**City of Kerrville Planning & Zoning Commission Agenda
Thursday, October 2, 2008, 4:30 p.m.**

City Hall City Council Chambers, 800 Junction Highway, Kerrville, TX

1 SITE PLAN
 SCALE: 1" = 20'-0"

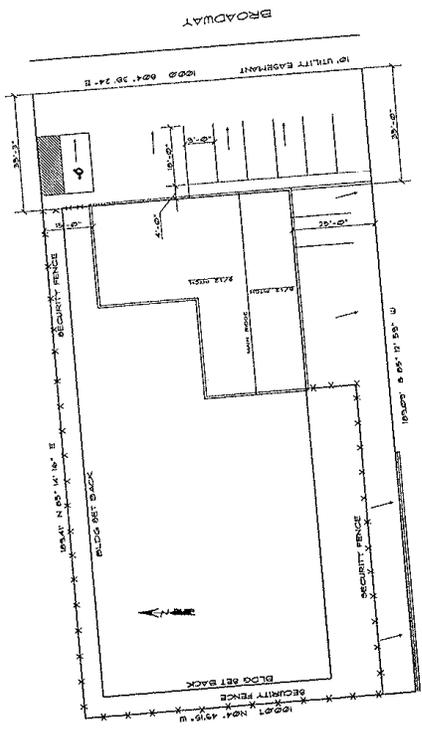
- As presented on the site plan, the applicant proposes to construct a new automotive repair facility at 1321 Broadway. The proposed use at this location requires a conditional use permit (CUP). As this area of the City begins a renewal in development, enhanced development standards should be encouraged to ensure sustainable development.

E. **Outside Storage:** The outside storage of any materials, equipment, or vehicles waiting for repair shall be behind the security fencing shown on the site plan.

- F. **Building Location and Orientation:** The location of the building shall be as indicated on **Exhibits A and B**.
- G. **Parking:** The design and number of parking spaces shall be in accordance with the City's regulations in effect at the time building permits are submitted to the City. All required parking spaces shall be constructed of asphalt or concrete and shall be marked and kept available for customers and employees.

- A. Site Plan and Elevation:** The development of the Property shall conform substantially with the site plan and elevations, which may be found in **Exhibits A and B**, and any additional development requirements as outlined herein.

2. A seven and one-half (7.5) foot wide landscape area shall be planted, parallel to and behind the sidewalk along Broadway and D Street. Along Broadway plantings shall consist of a continuous line of non-deciduous shrubs or bushes, no less than two (2) feet in height at maturity.

- K. **Sidewalks:** A five foot (5.0') wide sidewalk, constructed in conformance with City specifications, shall be required across the entire length of the Property adjacent to Broadway and D Street, save and except driveway areas.

**FUDDRUCKERS/
RETAIL DEVELOPMENT
OPTION 1**
U.S. HIGHWAY 27

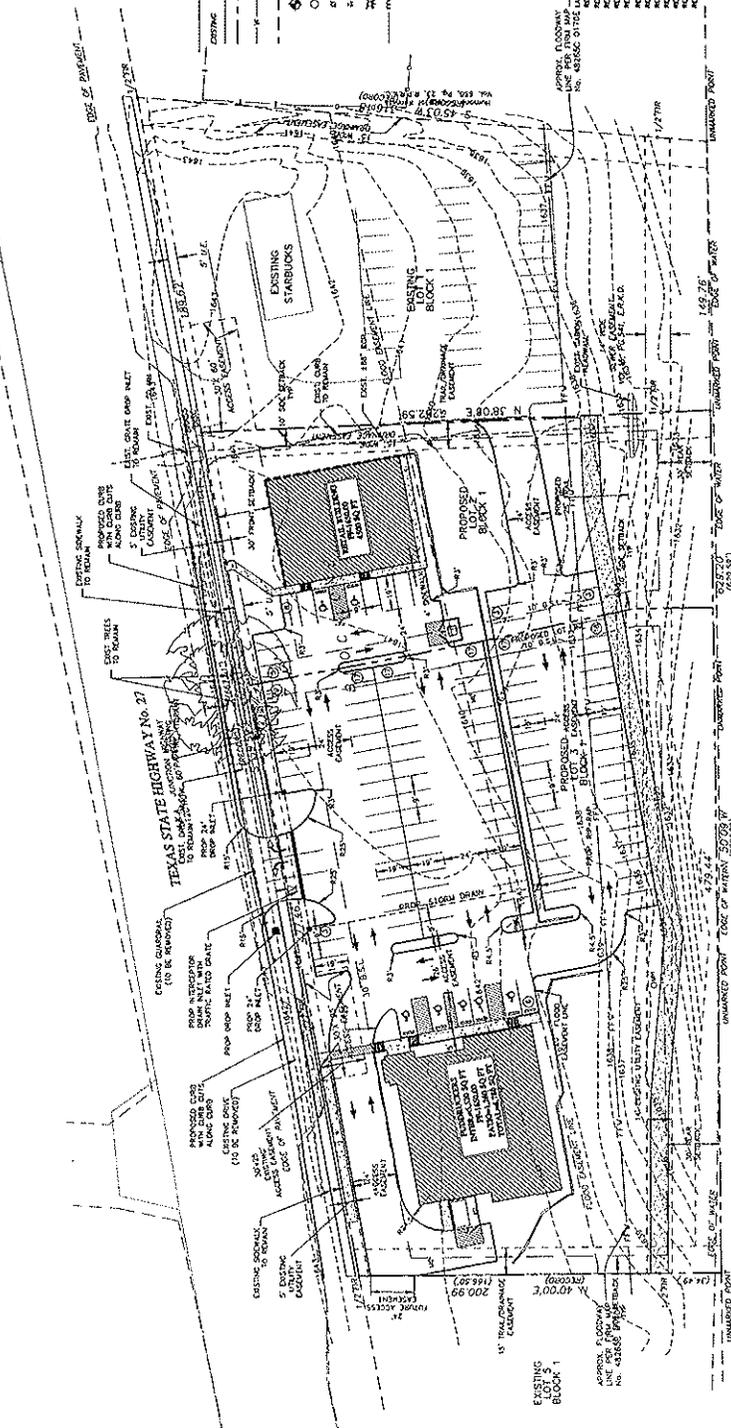
As you can see, the applicant has submitted two (2) site plans, titled Option 1 and Option 2. During the review of the amended site plan, staff and TxDOT recommended the continuation of the joint access easement between Lot 1 (Starbucks) and Lot 2. Option 2 shows that access point at the location of the platted easement. Option 1 shows an access point at the rear (back) of the property which allows for, we believe, better circulation between the two lots. Option 1 however, will require the consent and approval of the property owner of Lot 1 as well as a replat to establish the access easement. Therefore, staff and the applicant is requesting that the Commission review and consider both options with the understanding that only one site plan will be attached to the ordinance presented to Council. This will allow the applicant time (approximately 3 weeks) to contact the owner of Lot 1 and obtain there approval.

- The owner/developer must show on the replat, a public access easement across the river frontage of each lot as described in the ordinance. Staff has also requested trail easements along the 'exterior' lot lines of this development for construction of the City's River Trail project.
- A Development Site Plan must be approved by the Planning and Zoning Commission prior to the issuance of a building permit.
- All required construction and building plans must be approved prior to the issuance of a building permit.
